**Source:** Prestolite Leece-Neville Heavy Duty Systems  
**Bulletin No:** TSB-1231 **Date:** October 4, 2023  
**Models:** BLD / BLP4000  
**Subject:** Terminal identification when replacing Remy 55Si

**This document is to identify terminal variances between  
Prestolite BL4000 to Remy 55Si alternators.**

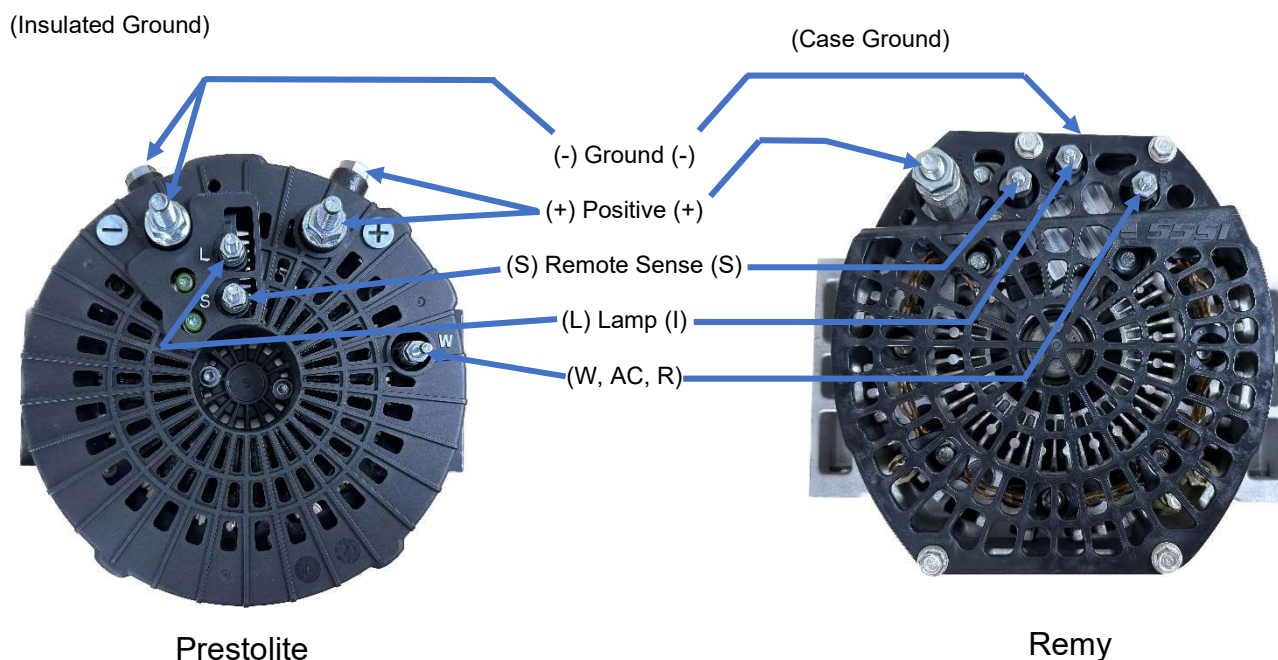
Note: Two positive and negative connections on BL4000 series alternators are common connections.

Remy 55Si alternators are case ground where the Prestolite BL4000 series uses isolated ground. Prestolite models requires a ground connection on a negative terminal for the alternator to operate.

Use the connection that works best in your application.
